PLAN COMMISSION STAFF REPORT
Wednesday, April 25, 2018
6:00 pm
ROOM 128 – CITY HALL – 7525 W. GREENFIELD AVE.

- 5A. Certified Survey Map to consolidate and re-divide the former AMF Bowling properties located at 10901 W Lapham St. and the 1600 Block of S. 108 St. (Tax Key Nos. 448-9979-005 & 448-9979-004)
- 5B. Special Use Permit for Coast Car Wash, LLC to establish a vehicle wash facility on vacant property (formerly AMF Bowling) located at 10901 W Lapham St.
- 5C. Site, Landscaping and Architectural Plans for Coast Car Wash, LLC to establish a vehicle wash facility on vacant property (formerly AMF Bowling) located at 10901 W Lapham St., submitted by Mike Klumb, applicant for Coast Car Wash, LLC (Tax Key No. 448-9979-005)

Certified Survey Map

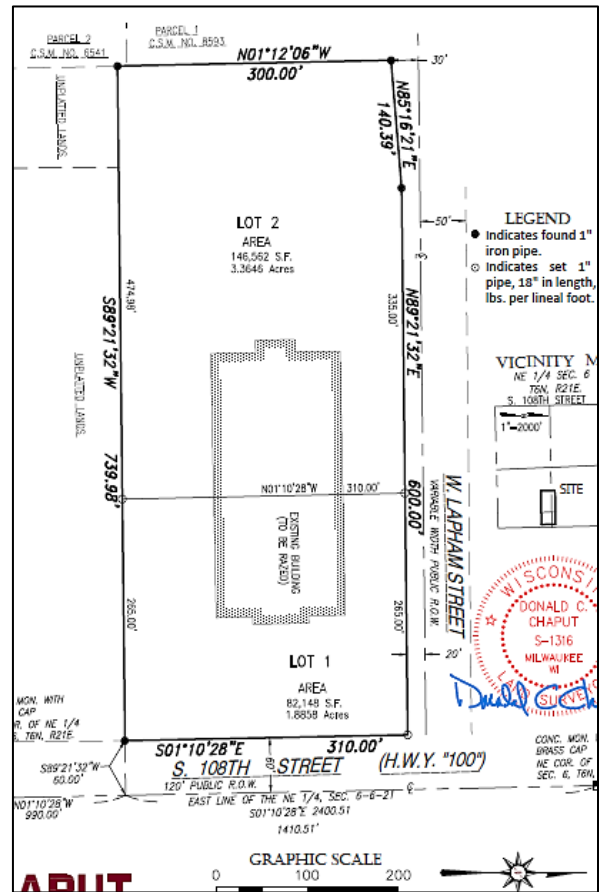
Since the former AMF site is comprised of two parcels (Tax Key No. 448-997-005 and 448-9979-004), the applicant is proposing to reconfigure the lots via a Certified Survey Map to create a proposed 1.8 acre site for the car wash and a 3.3 acre site for a future development (phase 2 – being marketed for future development).

In the event that no development is planned within 18-24 months of demolition approval, the owner would remove paved areas and replace them with grass.

Site and Landscaping

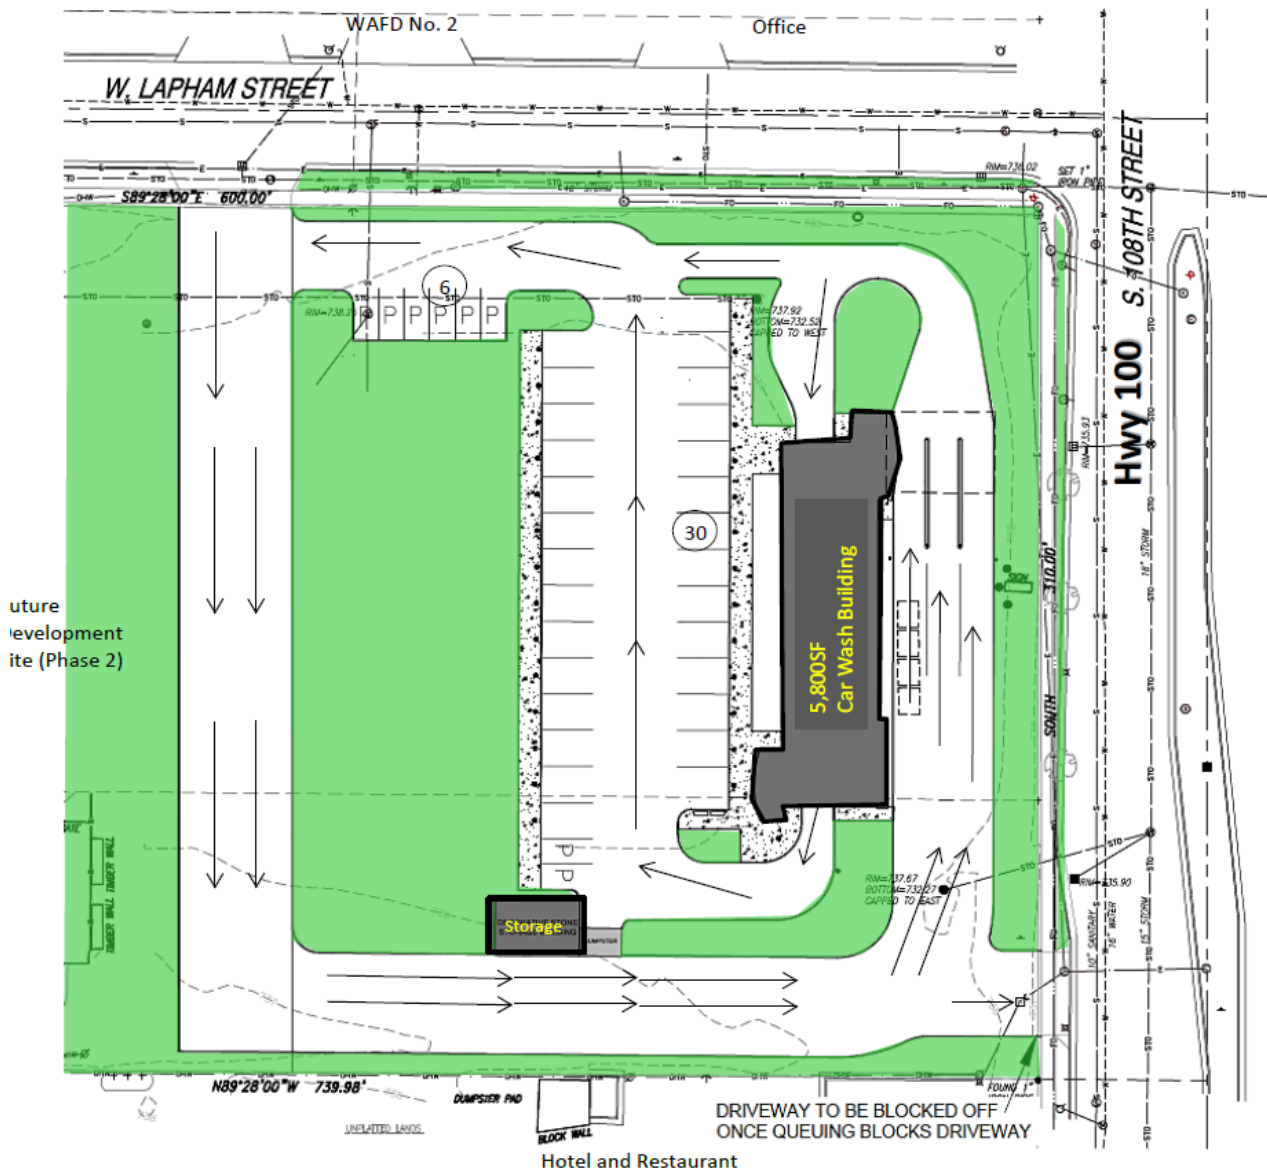
- Landscaping - is proposed and an update plan is being prepared. Our City Forester will also review updates. From the staff/landscaping perspective:
 - o We want to ensure that there will be proper screening around the perimeter of the site and to help protect surrounding uses including the hotel to the south and business to the north from headlights, sound, buffer/soften lines of site.

- o On the south side of the site a solid evergreen landscaping area, perhaps combined with that of a screen fence may be in order.
 - o Along the frontage of Hwy 100 a larger massing of perennial landscaping is recommended around the sign and at the northeast and southeast corners of the property.

- Cross access - While the future development to the west of the carwash is unknown at this point, the developer is planning on cross access between properties (recommended at least between properties).

1. Revised Site and Landscaping Plans being submitted to the Department of Development to show the following: (a) Additional landscaping is recommended internally and around the perimeter of the car wash site including perennial landscaping and trees (north, south, east and west); On the south side of the site a solid evergreen landscaping area, combined with that of a screen fence. Along the frontage of Hwy 100 a larger massing of perennial landscaping and trees is recommended around the sign and at the northeast and southeast corners of the property (b) Hwy 100 driveway being modified directionally to right turn exit only; (c) on the south end of the site, reduce lane widths of the proposed (40-ft) wide internal east-west queuing/stacking drive lanes (as proposed 13-ft wide – reduce to 11-ft wide); (d) site plan to show queuing/stacking on site; (e) vacuum operational and design details being noted (sound level, pay per use, free, central vacuum or dual on board canister, lighting); (f) architectural details and color specifics being provided on an updated set of elevations. Contact Steve Schaer, City Planner at (414) 302-8466 with any questions.
